## **PRELIMINARY REPORT EDITORIAL TASK GROUP**

**January 3, 2014**

## **ICC/ANSI A117.1 STANDARD DEVELOPMENT - 2014 EDITION**

**Fig. 605.2 Height of Urinals**

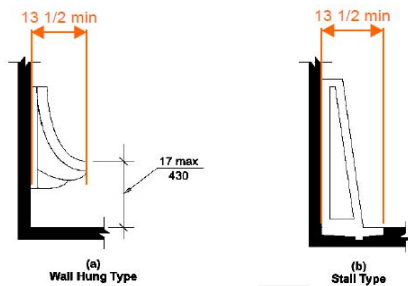
**Do we want to add minimum project since it now applies to all?**

**Comment [FA5]:** OK, but ETG to ask Committee - Add "building" in front of wall? Or is it urinal wall? In the text.

**Fig. 608.3.1 Grab Bars in Transfer-Type Showers**

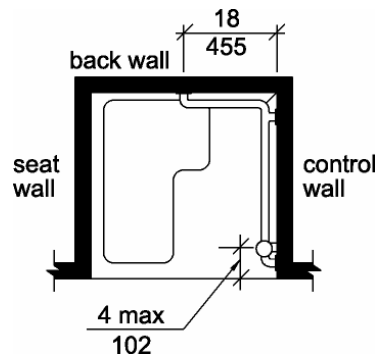
**Comment [FA8]:** Seat and bar in drawing need to be re-scaled. Conflict that needs to be resolved by the committee. "Front edge" is unclear.

**A new figure for this new exception??**  
**Fig. 1104.11.3.1.3.3**

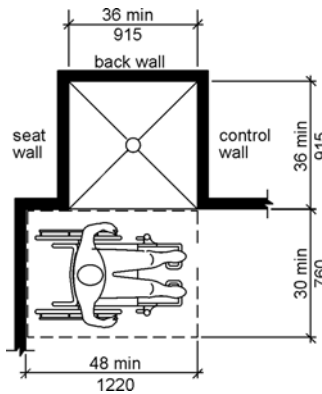
**Comment [FA16]:** Yes, but what does the clear floor space align with? Should it be 12" behind the seat wall or with this being 44" should it only be 8"? Should the clear floor space be aligned with the control wall? Also need to clarify if seat blocking is required. Also need to discuss consistency with other conditions. Is 36" minimum between the walls or is it the door width or both? Also need to match shower head/control wall. Take to full committee for clarification.
